Project	IEEE 802.16 Broadband Wireless Access Working Group < http://ieee802.org/16 >	
Title	The Efficient Anchor BS Update Starting Mechanism	
Date Submitted	2004-11-04	
Source(s)	Min-Sung Kim, Yongjoo Tcha, Seong-Choon Lee KT 17 Woomyeon-dong, Seocho-gu, Seoul, 137-792, Korea Seung-Hun Oh, Young-Han Kim SoongSil University Sangdo-dong, Dongjak-Gu, Seoul, 156-743, Korea	Voice: +82-2-526-6109 Fax: +82-2-526-5200 mailto:cyberk@kt.co.kr Voice: +82-2-814-0151 mailto:yhkim@dsn.ssu.ac.kr
Re:	IEEE P802.16e/D5-2004	
Abstract	In this contribution, we add a timer mechanism into Anchor BS Update to make clear when to start anchor BS update.	
Purpose	Discuss and adopt the suggestion into P802.16e/D6.	
Notice	This document has been prepared to assist IEEE 802.16. It is offered as a basis for discussion and is not binding on the contributing individual(s) or organization(s). The material in this document is subject to change in form and content after further study. The contributor(s) reserve(s) the right to add, amend or withdraw material contained herein.

The Efficient Anchor BS Update Starting Mechanism

Fig. 1 The situation where the MSS decides to start the Anchor BS Update.

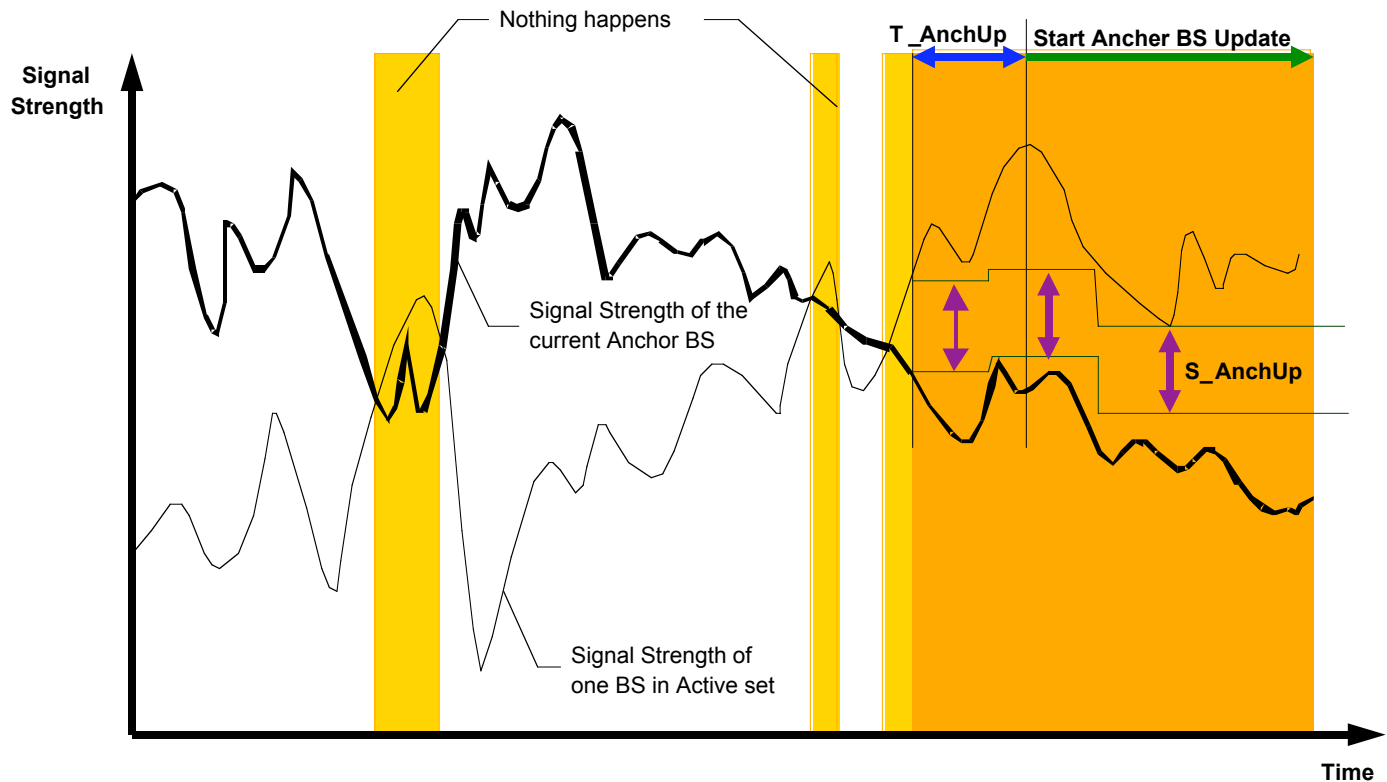
To make correct decision of anchor BS update, we propose a timer mechanism with signaling differential threshold. For the real anchor BS update to be guaranteed, the situation where the MSS decides to start one of the Anchor BS Update mechanisms is that the signal strength of one BS in the active set is higher than that of the current anchor BS by a certain threshold (we define as S_AnchUp) for a certain duration (we define as T_AnchUp). In the Fig. 1, the signal strength of the BS in the active set is larger than that of the current anchor BS three times. The first two cases happen just for a short time and their signal differences are lower than S_AnchUP . However, the signal difference of the last case is getting larger than S_AnchUp and is kept for larger duration than T_AnchUp . Finally, T_AnchUp after the signal difference becomes larger than S_AnchUp , the MSS will start Anchor BS Update.
